# A63 Castle Street Improvement, Hull

## DCO Documents Errata

TR010016/APP/6.1  
HE51408-MMSJV-GEN-S0-RP-ZH-000016  
~~10-20~~ September 2019

Drawing Title: **VOLUME 2 FIGURE 2.5.6 THE SCHEME PROPOSALS - SHEET 5 OF 6**

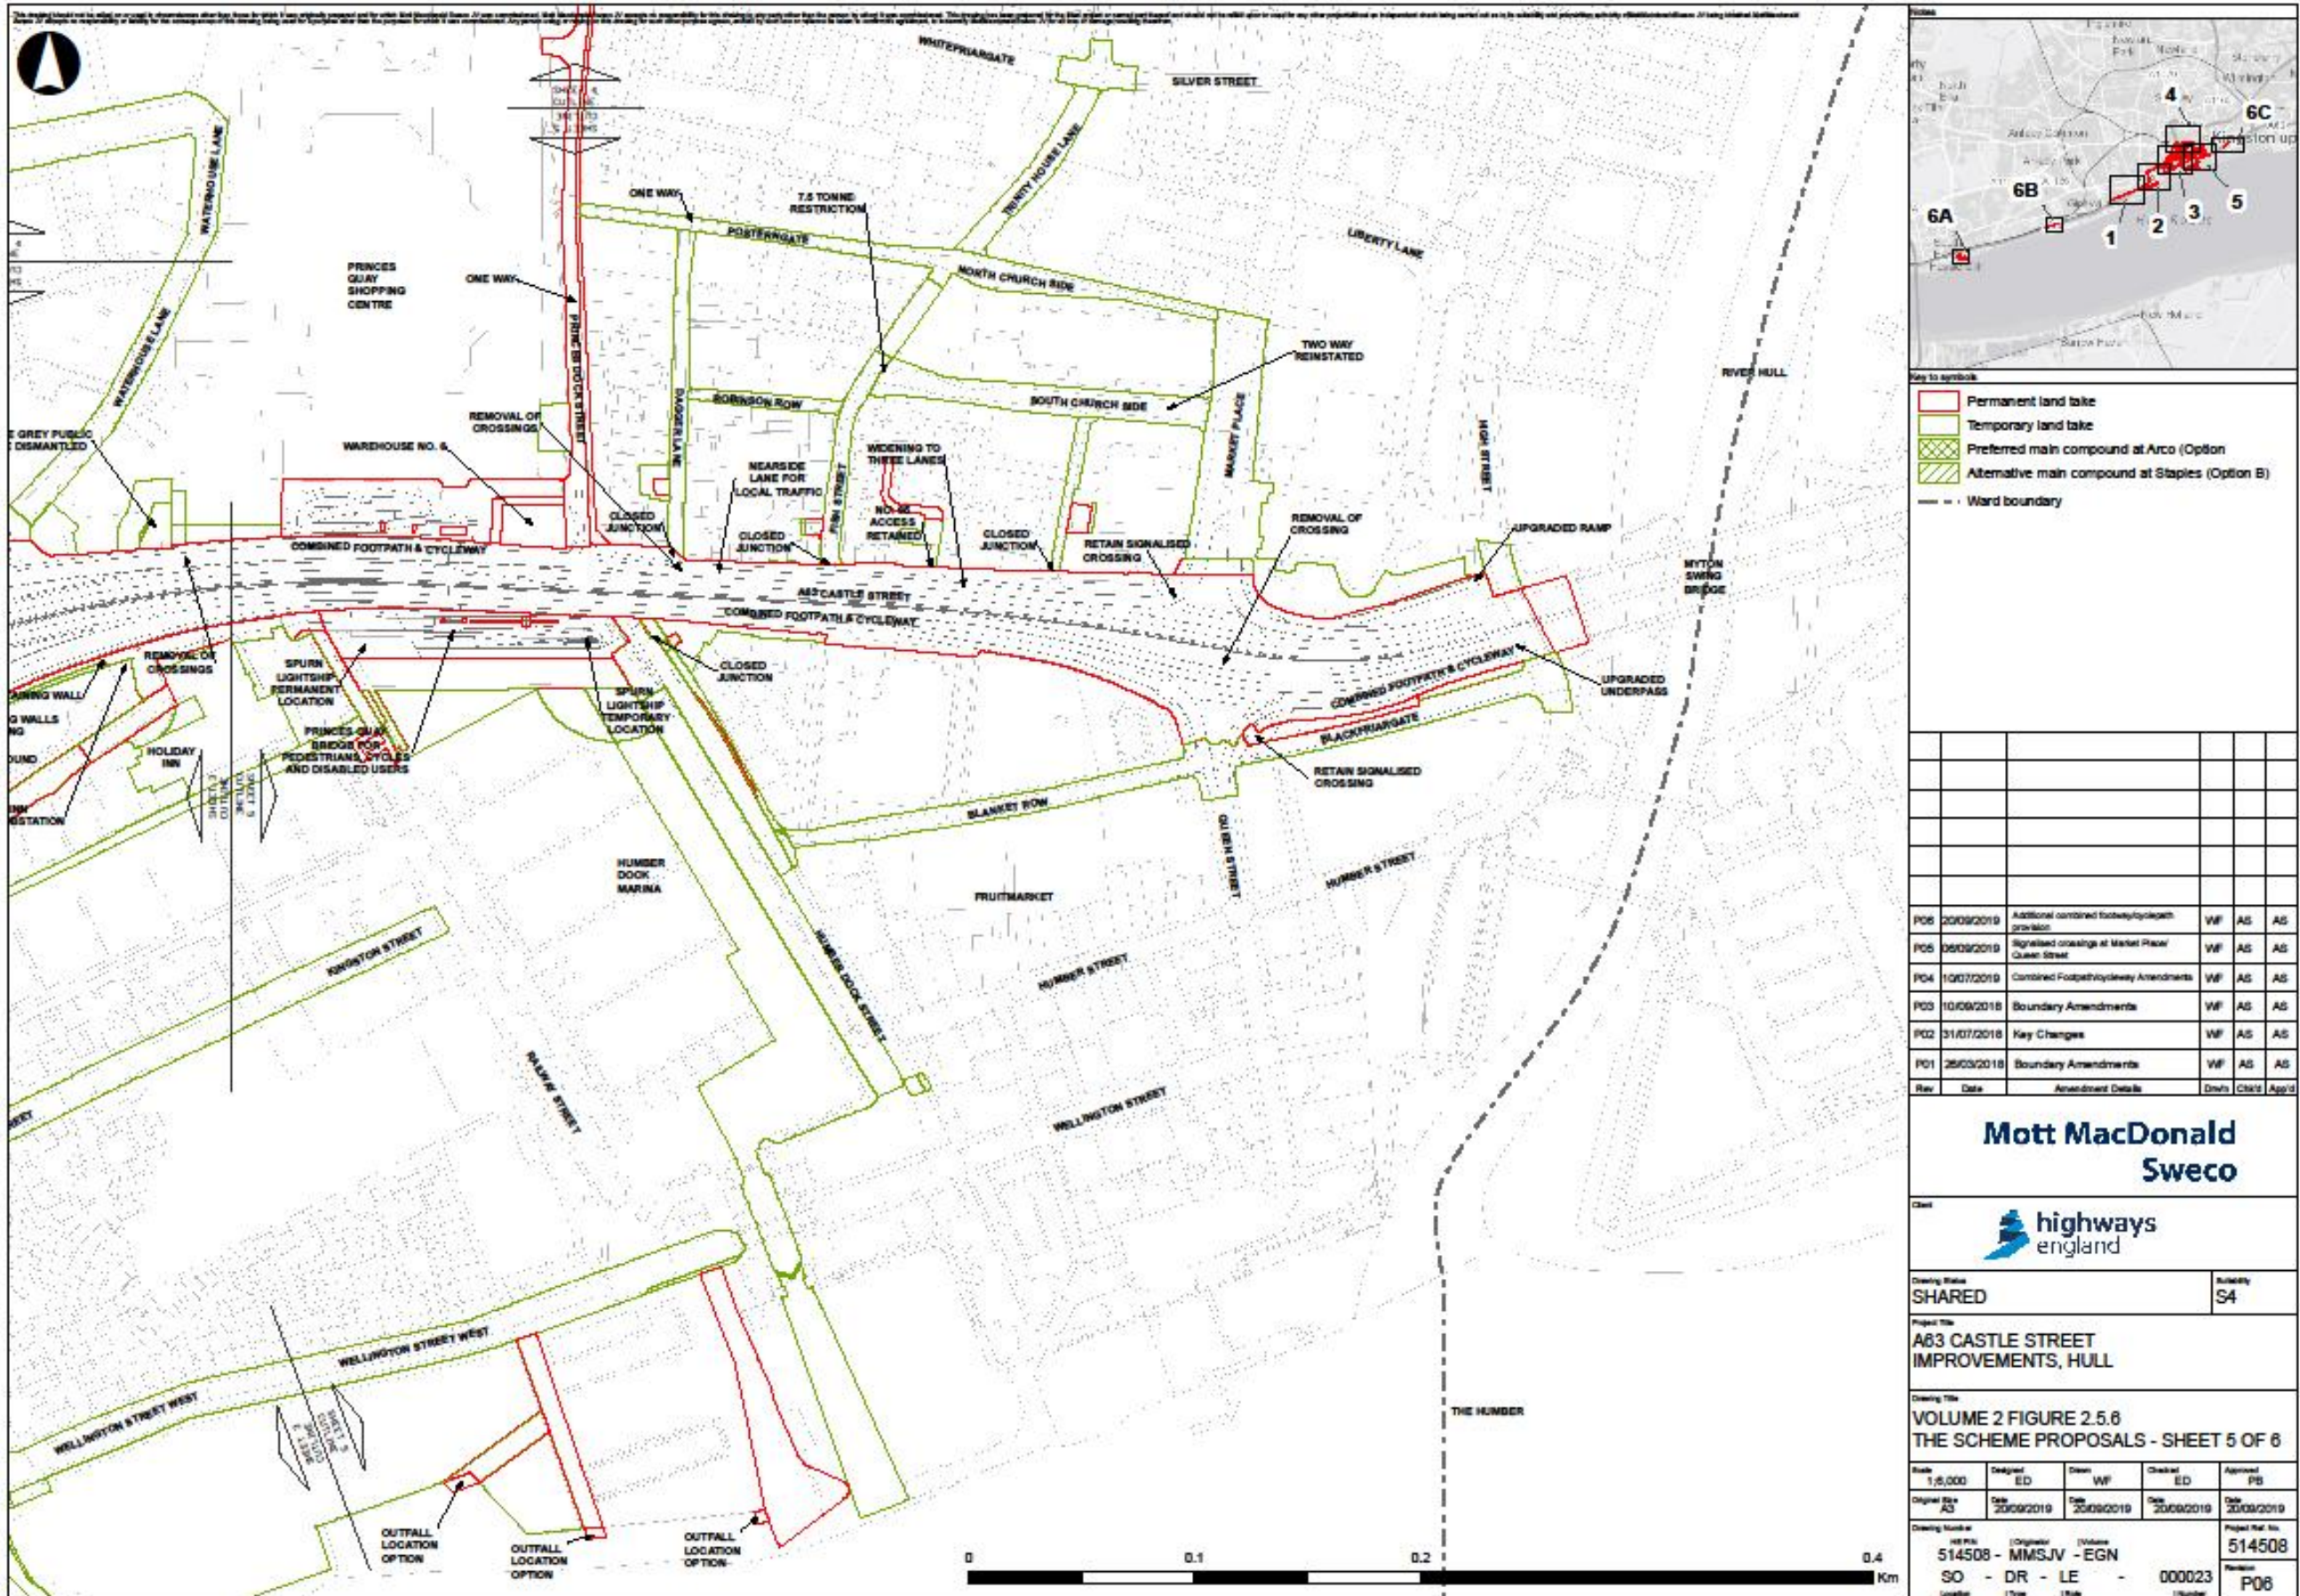
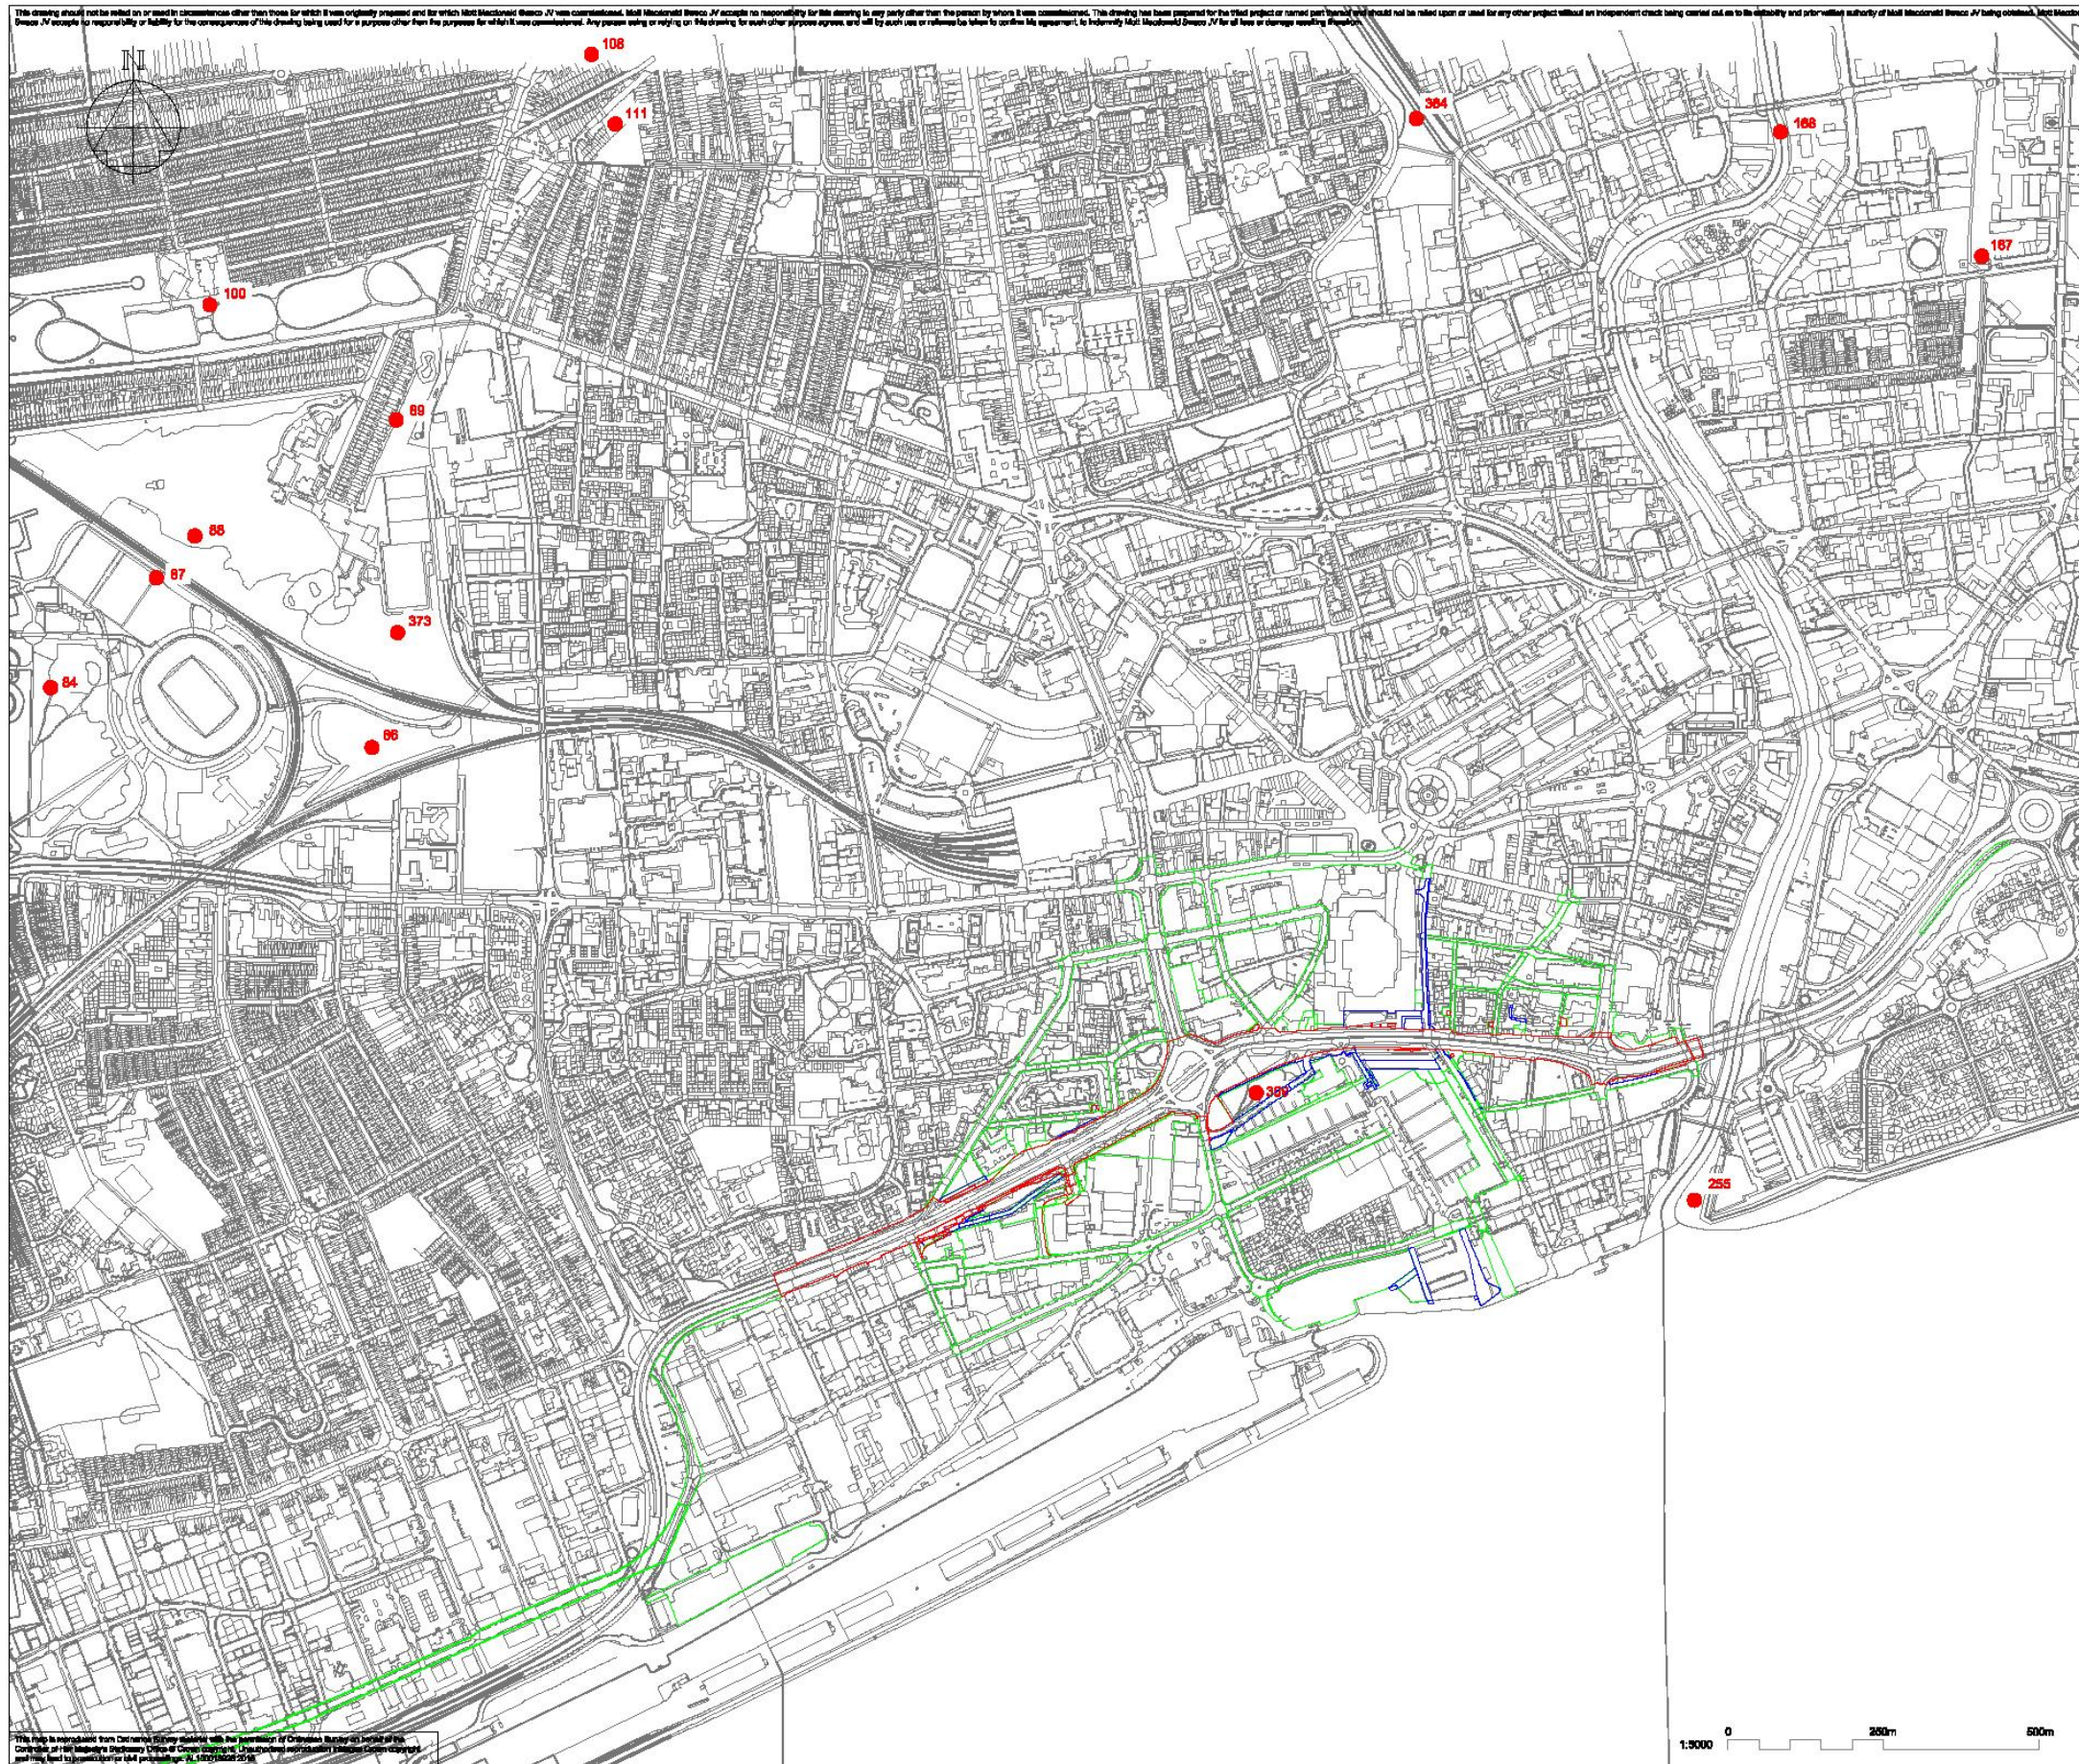
3.1.1 Replace ES Volume 2 Figure 2.5.4 The Scheme Proposals – Sheet 3 of 6 and Figure 2.5.6 The Scheme Proposals – Sheet 5 of 6 (APP-025) with the new Figures 2.5.4 and 2.5.6 below. Changes are as follows:

- Locations of the combined footpath & cycleway have been ~~clarified~~revised.
- Signalised crossings at Market Place and Queen Street are to be retained.

Drawing Title: VOLUME 2. FIGURE 15.2 PROPOSED NON-MOTORISED USERS FACILITIES AND CLOSURE FOR THE SCHEME

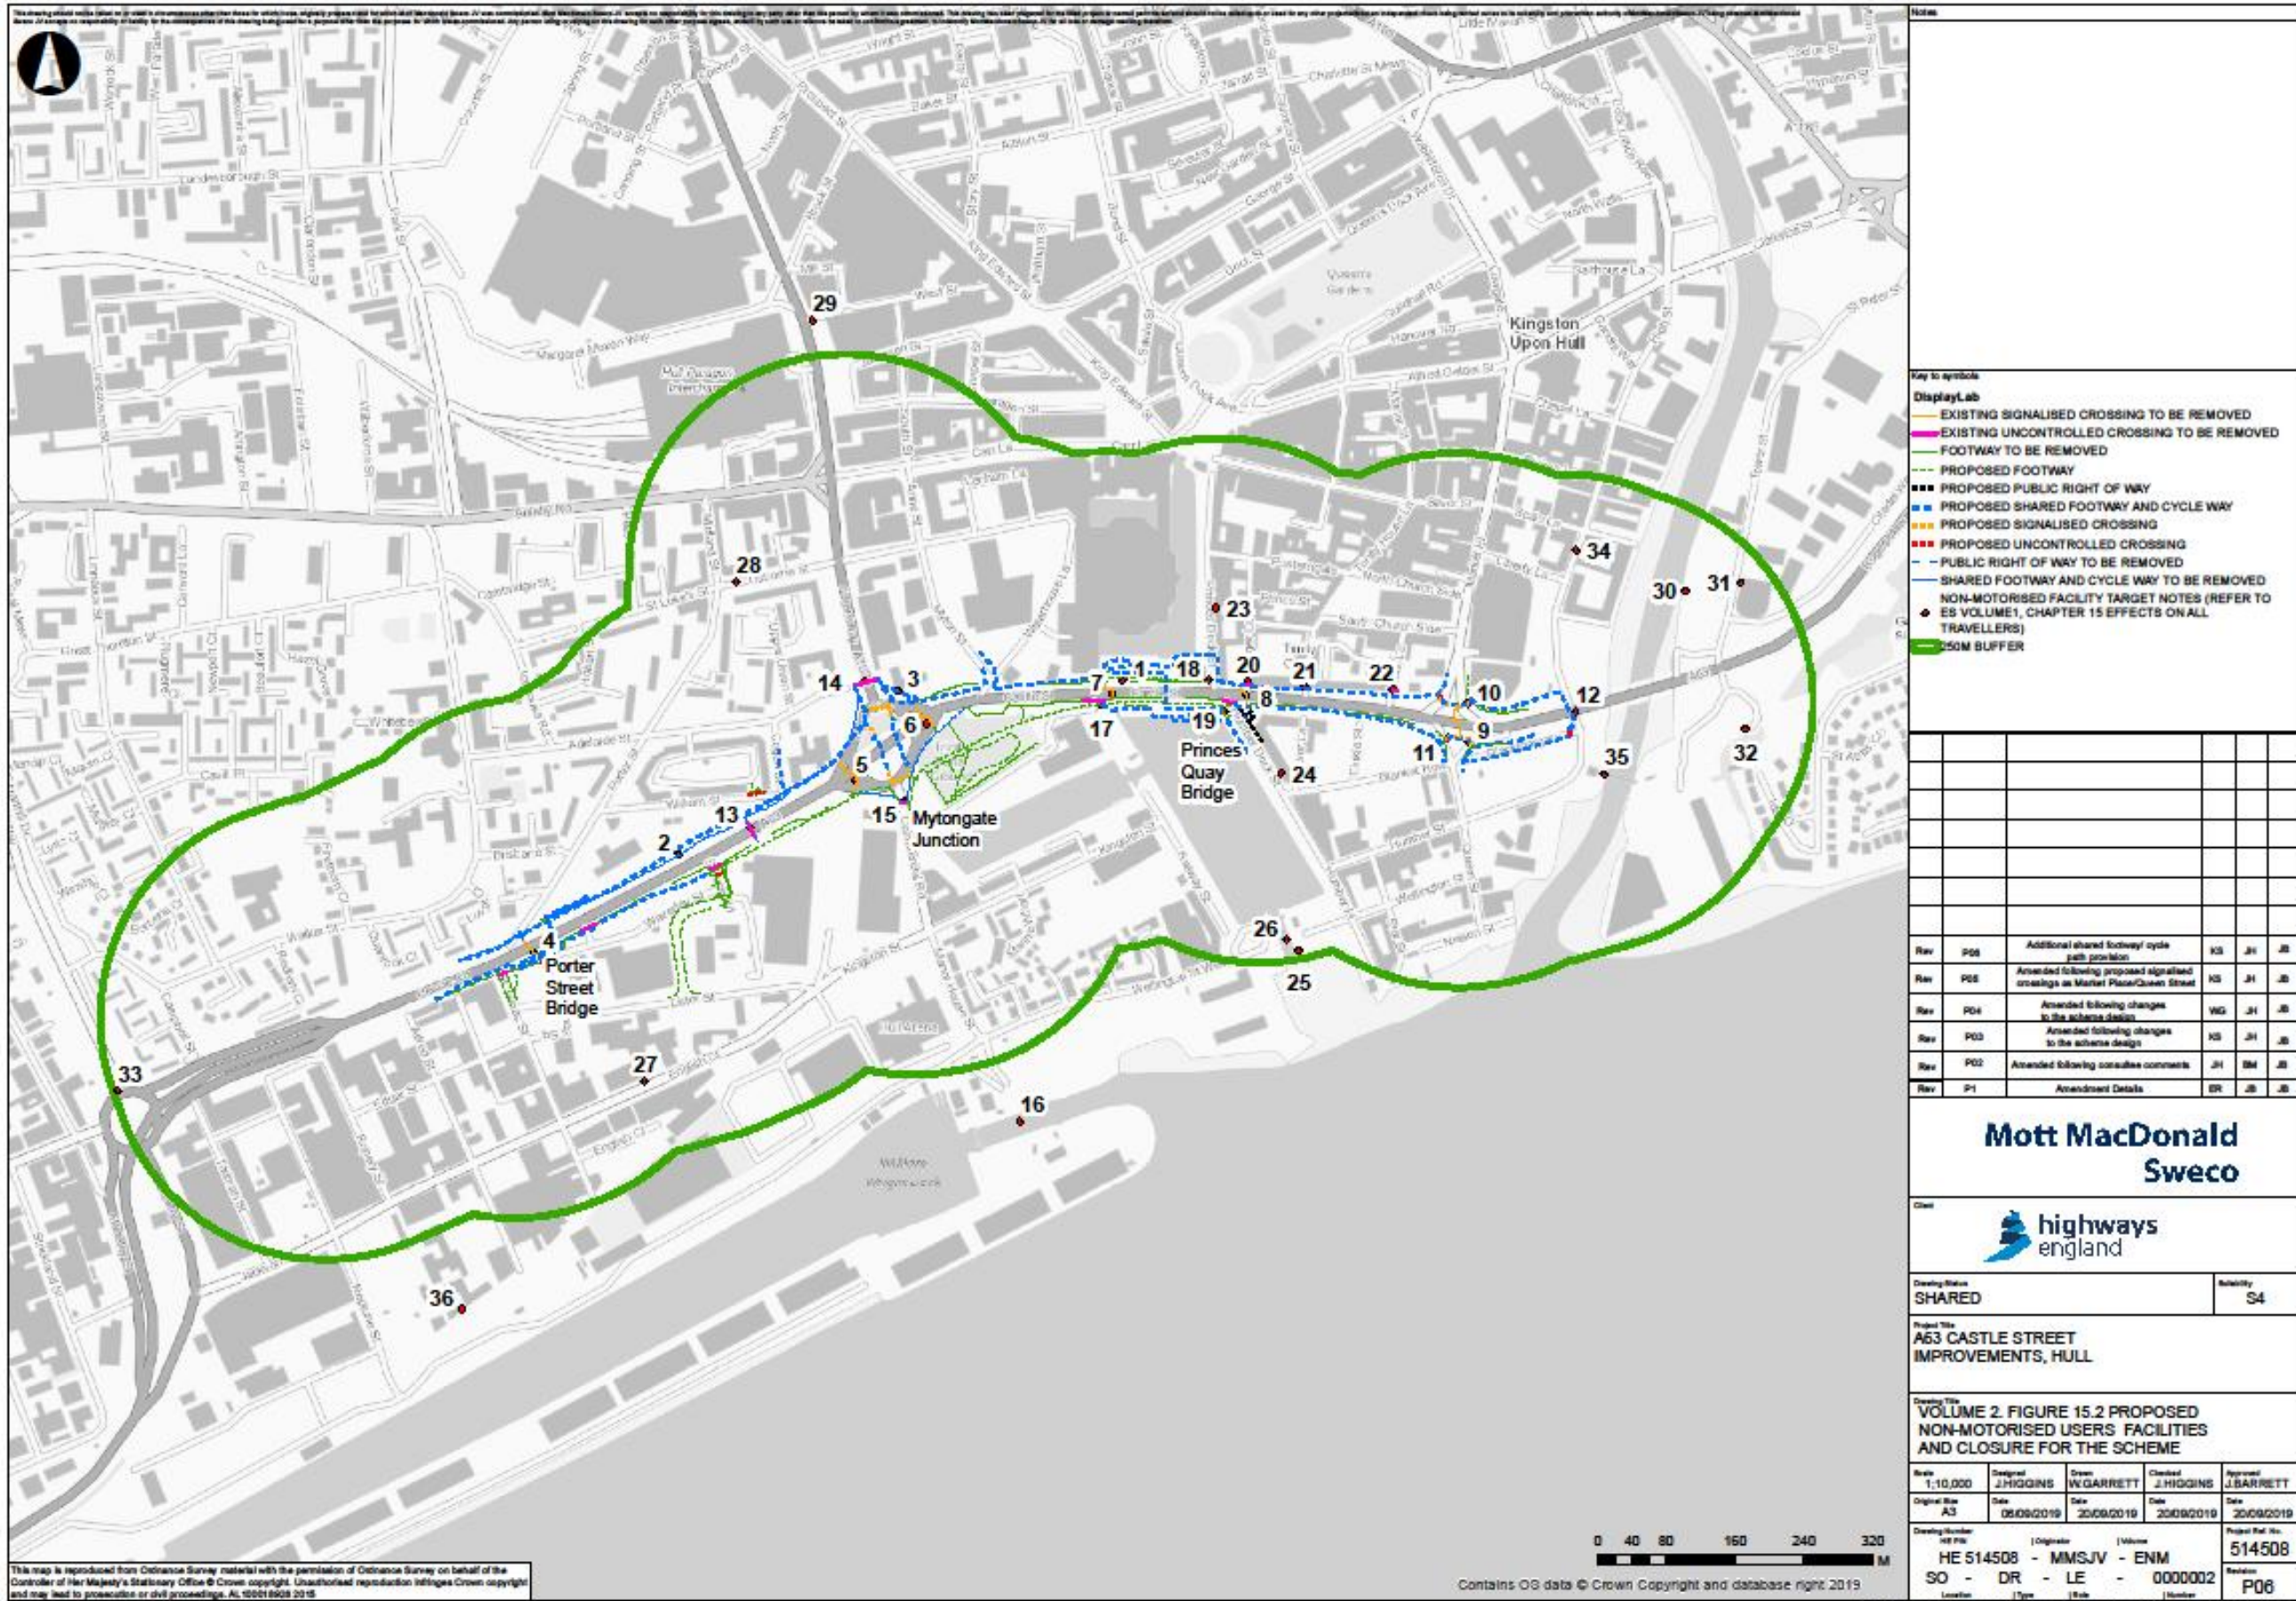
5.1.1 Replace ES Volume 2 Figure 15.2 Proposed non-motorised users facilities and closure for the Scheme (APP-040) with the revised Figure 15.2 as below. Changes are as follows:

- Locations of the combined footpath & cycleway have been ~~clarified~~revised.
- Signalised crossings at Market Place and Queen Street are to be retained.
